Design Review Committee Meeting

700 Doug Davis Drive
Hapeville, GA 30354

September 15, 2021 6:00 PM

4.I. 482 Walnut Street Porch Remodel

ELEVATIONS

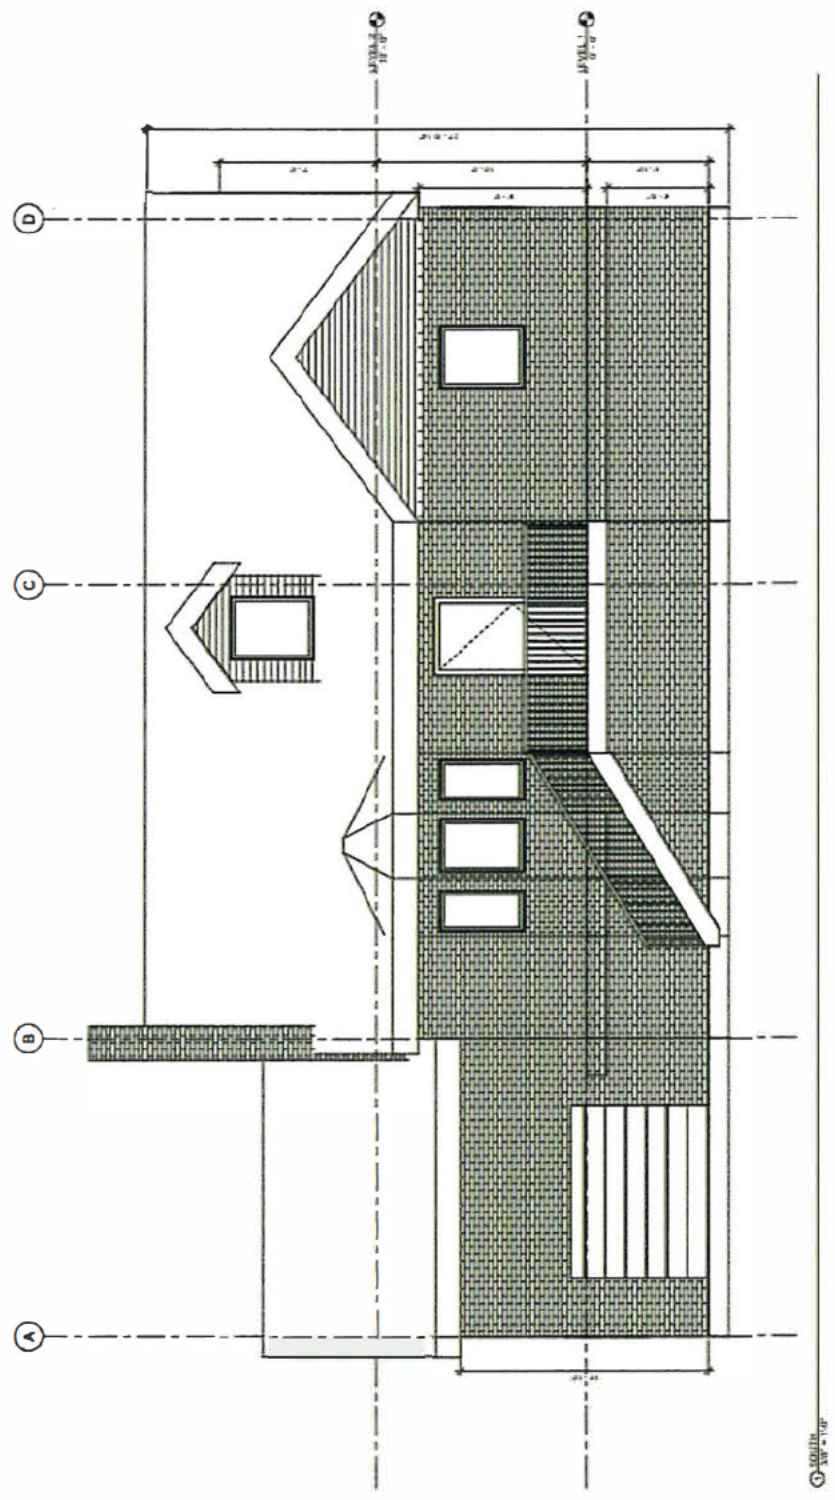
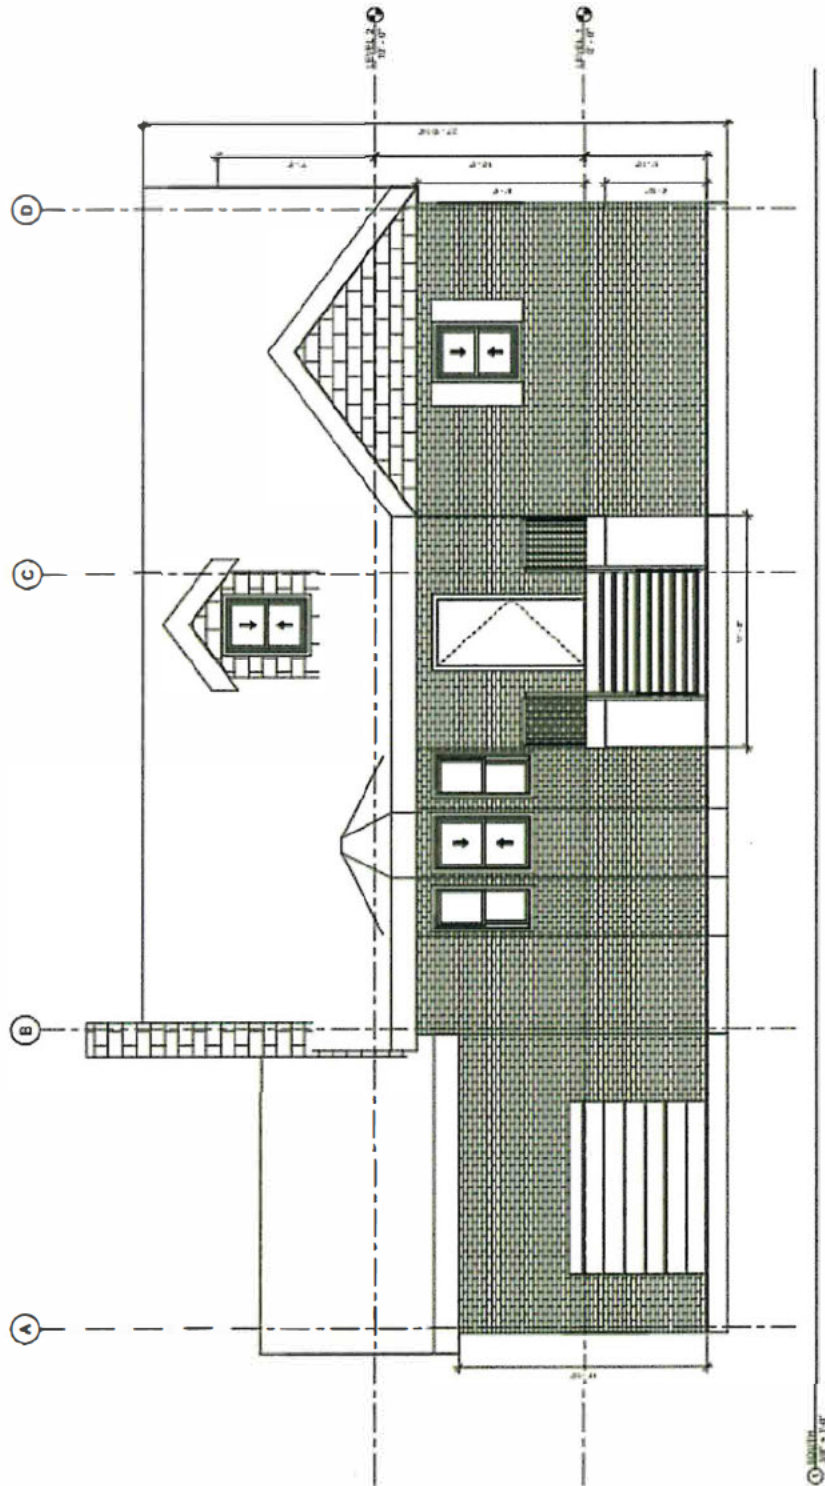
STAFF COMMENT: Detailed information for the porch replacement has not been provided: will the new wood be painted or stained, railing dimensions, landing dimensions, size of land, if stair risers and foundations are enclosed.

The drawings appear to show a change in façade materials. Applicant should clarify whether stone will be replacing the lap siding. Beneath the gables and in the dormer.

SHEET NUMBER
A2.1

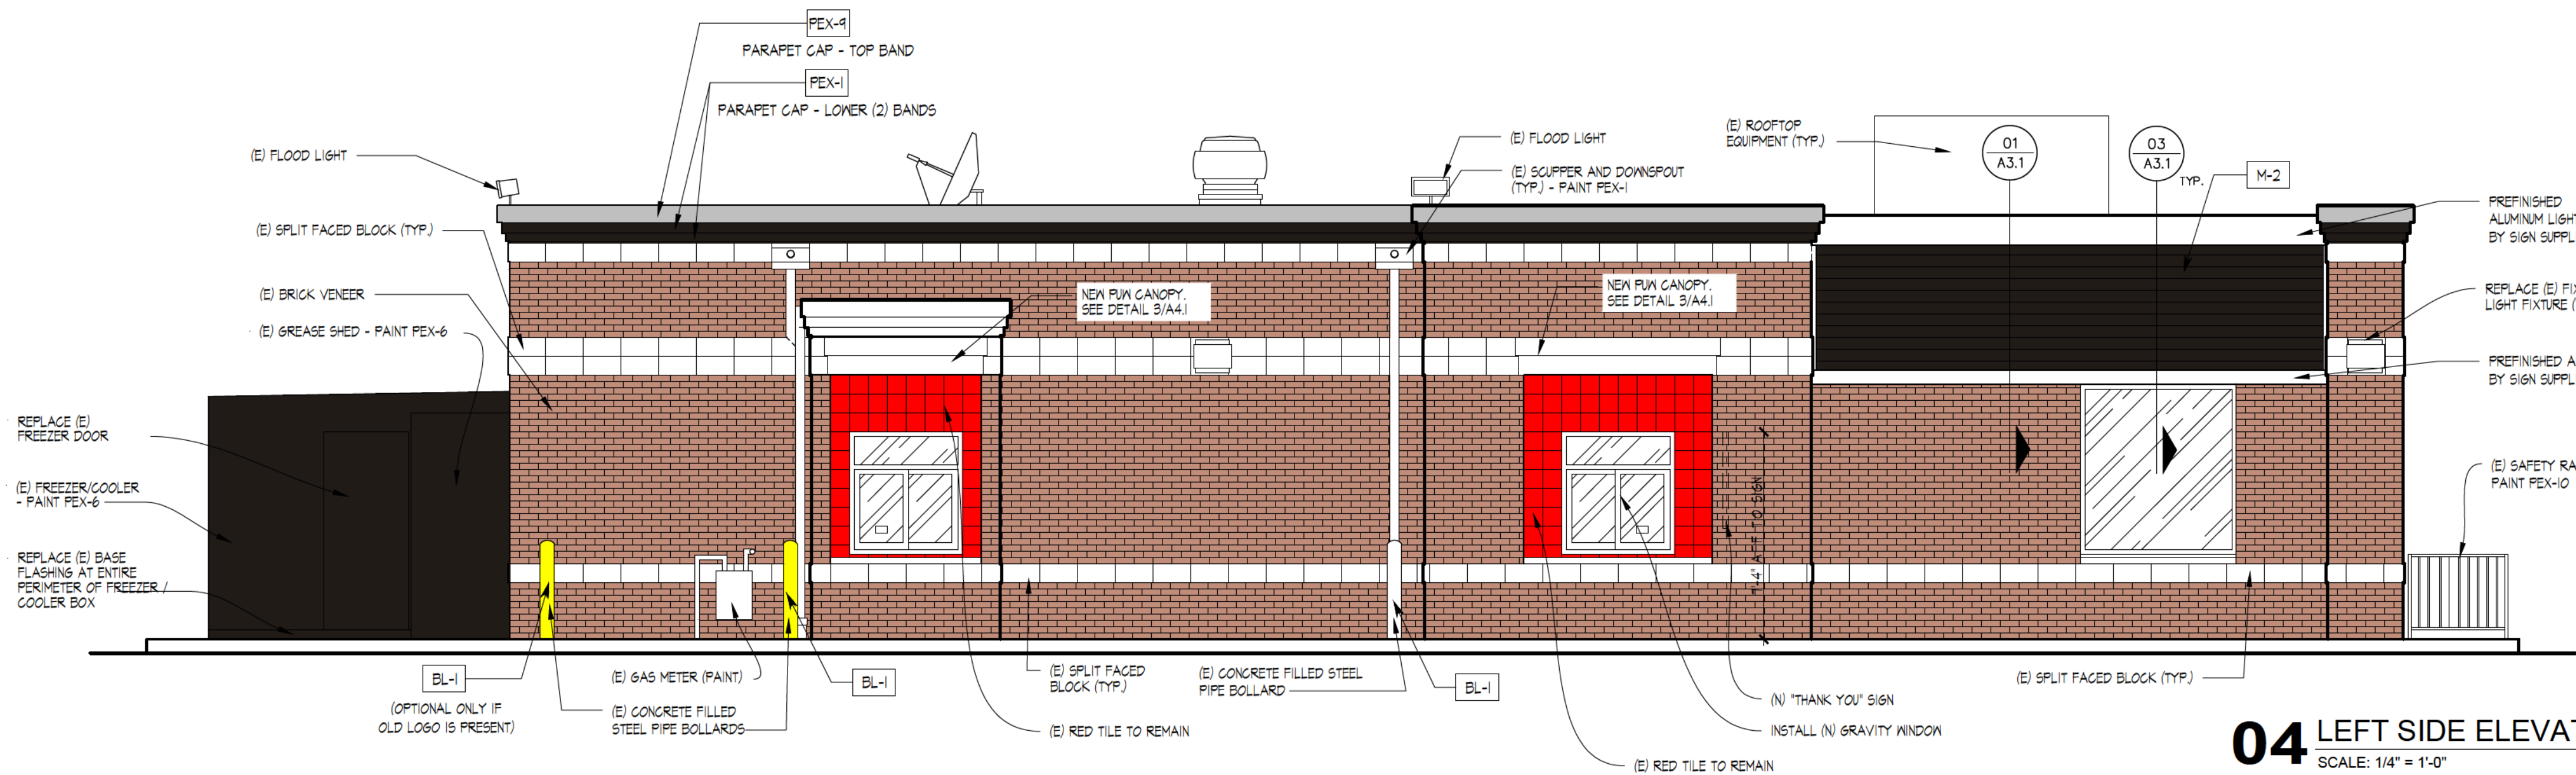
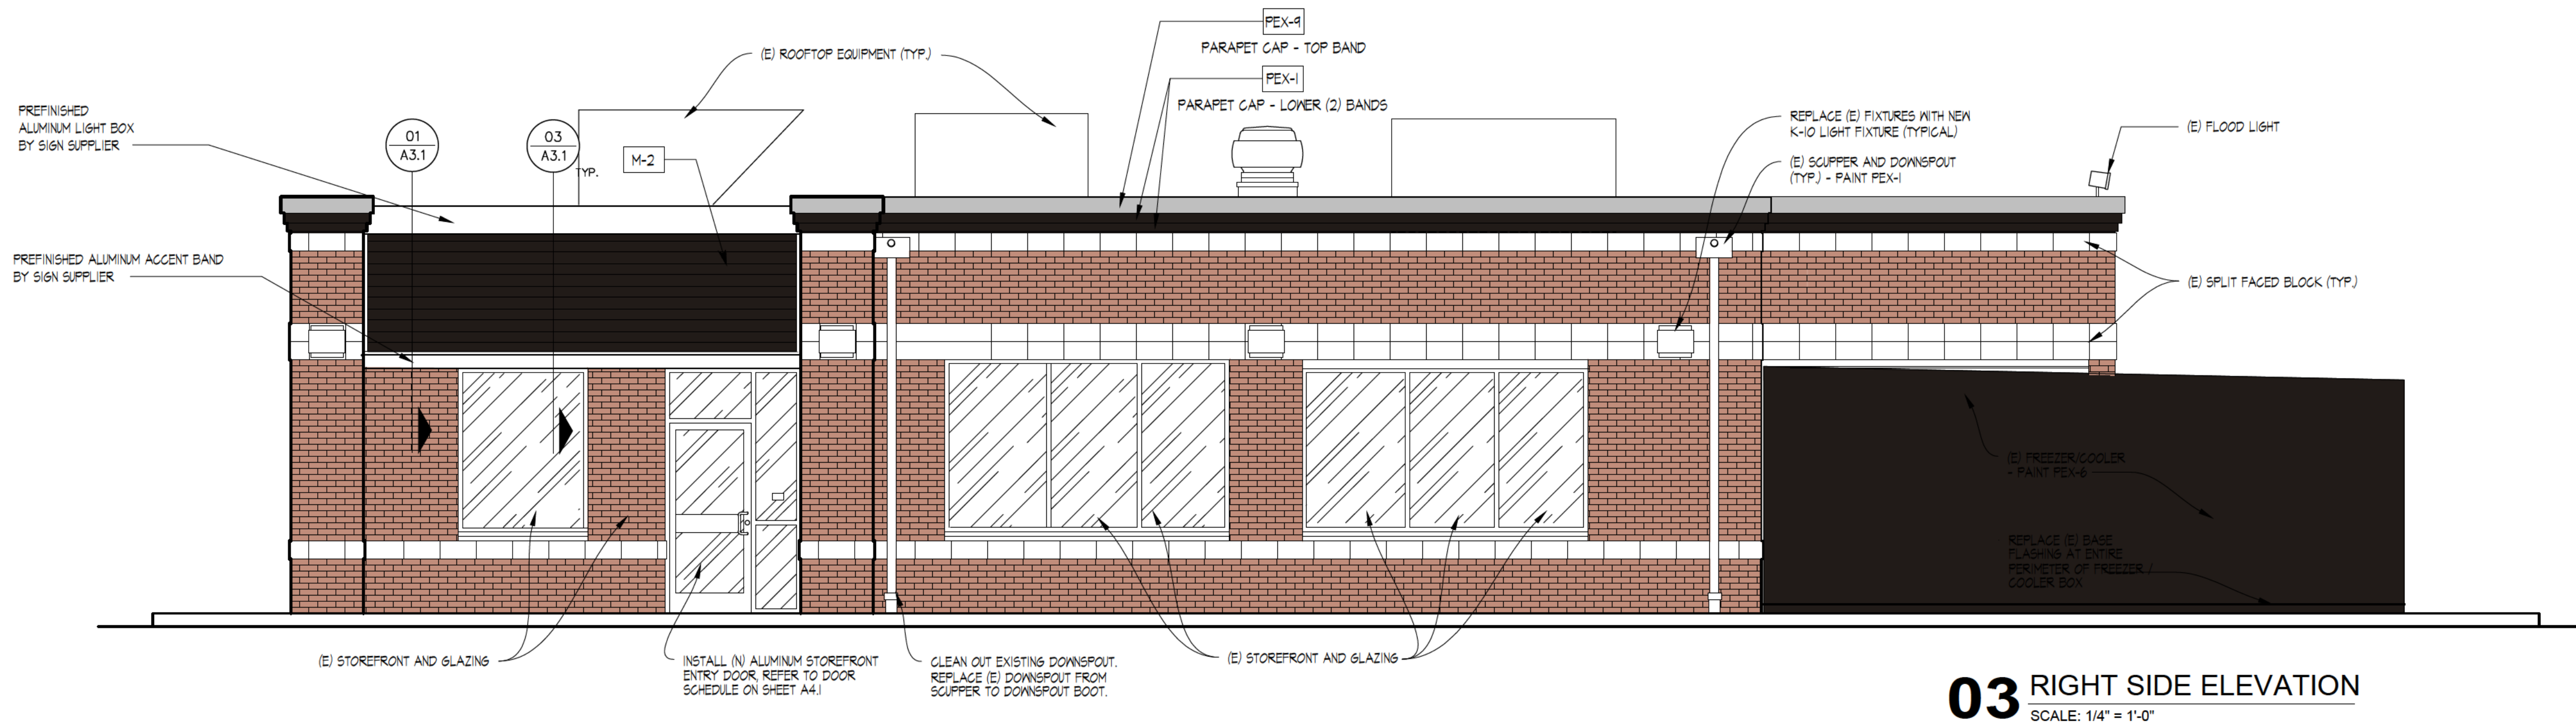
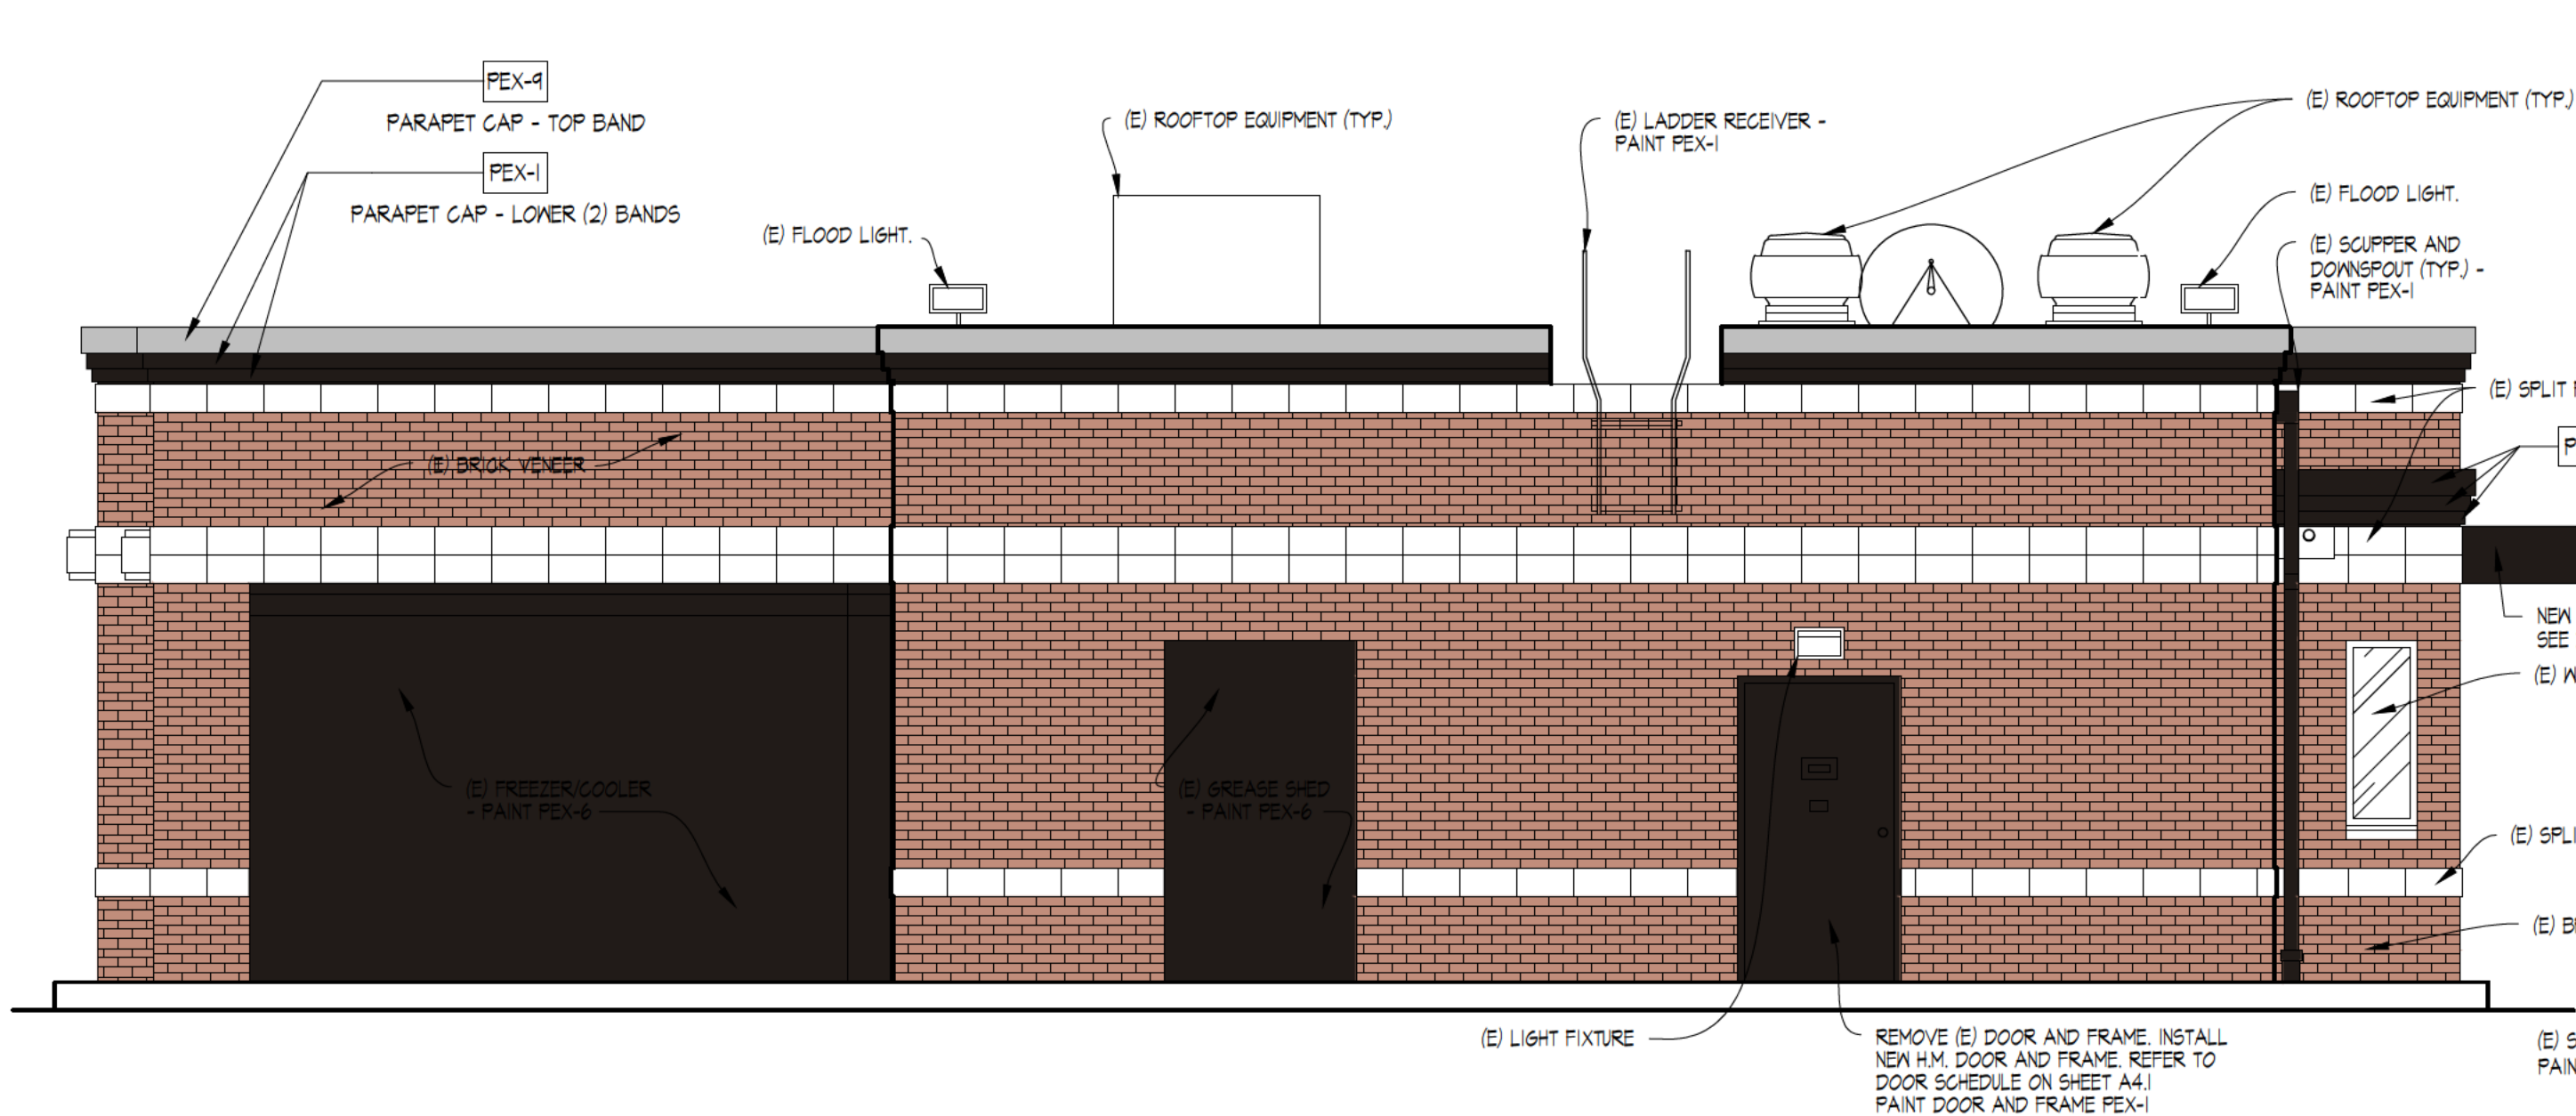
***Applicant should provide canopy information. Design Exception recommended for drive through canopy material and dimensions.
All signs require sign permit.***
